REF: JD 09/91

ERRATA

XJ6 MODELS

REF: JD 26/93

FIG 1

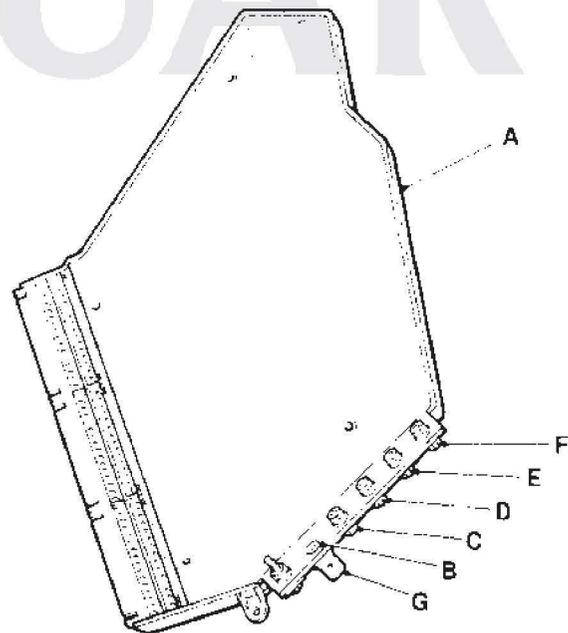
Following investigations into the cause of air conditioning/heater unit rotary flaps 'sticking', a concern has been identified with the servo motor drive ICs retained to the heatsink on the microprocessor unit. On a number of ECUs, the earth points have been found to be electrically poor, causing permanent or intermittent failure of the servo drives. The effect of this, in vehicle, is the 'sticking flaps' problem where the flaps appear to be jammed, although it is the ECU which is at fault.

In the event of a vehicle being returned with either an upper or lower rotary flap problem, i.e. intermittent or permanent sticking, the Dealer should carry-out the following procedure before any further action is taken:-

1. Initially determine in what mode the upper or lower rotary flap is jammed, i.e. cooling or heat mode.
2. Remove the necessary trim items from the right-hand side of the unit to gain access to the microprocessor assembly, Fig 1 (A).
3. Switch-on the ignition and air con/heater system. Select manual override. Having already determined in which mode the rotary flap in question is jammed, rotate the temperature demand control in the opposite direction; i.e. if, for instance, the rotary flap is stuck in the cooling mode, turn the

4. Using a digital voltmeter, touch one lead on to the earth rivet Fig 1 (B). Then, in turn, probe each of the four earth connection bolts, Fig 1 (C, D, E and F); if the earth connections are satisfactory, '0' volts will be indicated. If, during probing, any one of the four readings is abnormally higher, this will indicate a poor earth track.

5. If a higher reading is identified, check the tightness of the earth bolt affected. Tighten if necessary and re-check the voltage. (The Dealer may also check the tightness of the other earth bolts as a precaution).

6. If the voltage reading returns to '0' volts, re-check the system operation. (If the fault persists, proceed to point 8).
7. If the voltage reading remains high, turn-off the ignition. Release and remove the earth bolt and check for any signs of contamination, oxidization, etc. Using a very fine abrasive paper (P1000 or above), clean the earth track as shown in Fig 2. Ensure that both the microprocessor heat sink surface (H) and the power transistor bracket surface (J) are cleaned.

Replace the bolt, re-tighten, switch-on the ignition and re-check the voltage reading. If the voltage reading indicates '0' volts, the fault should be corrected. Re-check the system operation.

FIG 2

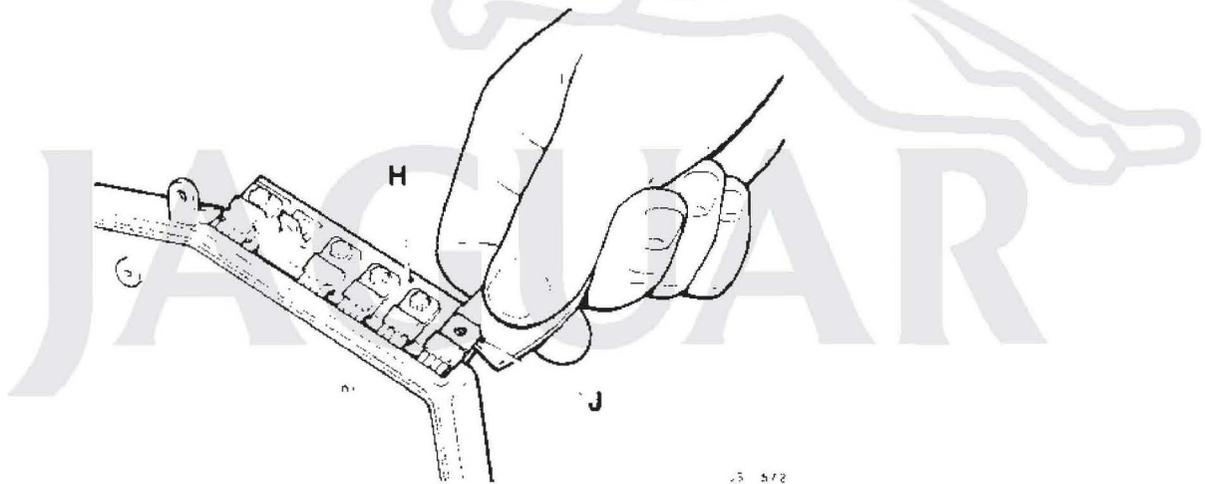
IMPORTANT: Do not bend the power transistor away from the heatsink as permanent damage may be caused to the PCB connections. Slide the abrasive paper between the heatsink and the transistor bracket.

FIG. 1

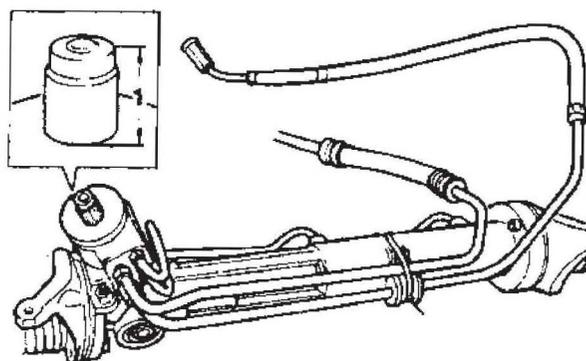
INTRODUCTION OF THE ZF PHASE 2 STEERING RACK

The ZF Phase 2 Steering Rack (Fig. 1) is added to the 1994 MY specification. The rack body consists of two aluminium pressure diecastings; the rack mounting is unchanged. The pinion height (1, Fig. 1) is increased by 7mm; the steering column is altered to accommodate this change. The fluid pipe union positions in the valve block are also altered, with the fluid pipes being modified accordingly. The steering rack assembly is a non-serviceable item.

FIG. 2

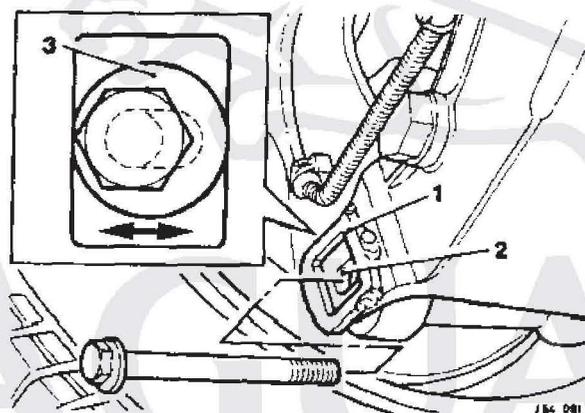
INTRODUCTION OF REAR WHEEL ALIGNMENT ADJUSTMENT

A system of rear wheel alignment adjustment is now incorporated in the rear suspension assembly.

The lower suspension arm has a plate, with a rectangular recess machined in the centre, added to the rear pivot eye (1, Fig. 2). The suspension arm pivot bolt hole (2, Fig. 2) is elongated, horizontally, at this point.

The pivot bolt has an integral eccentric (3, Fig. 2) below the bolt head, which, when in position in the plate, has a slight clearance at the sides but full clearance at the top and bottom. Rotation of the bolt head, with the eccentric constrained between the vertical faces, causes the bolt shank to be moved in the horizontal plane, thus displacing the hub carrier and effecting wheel alignment adjustment.
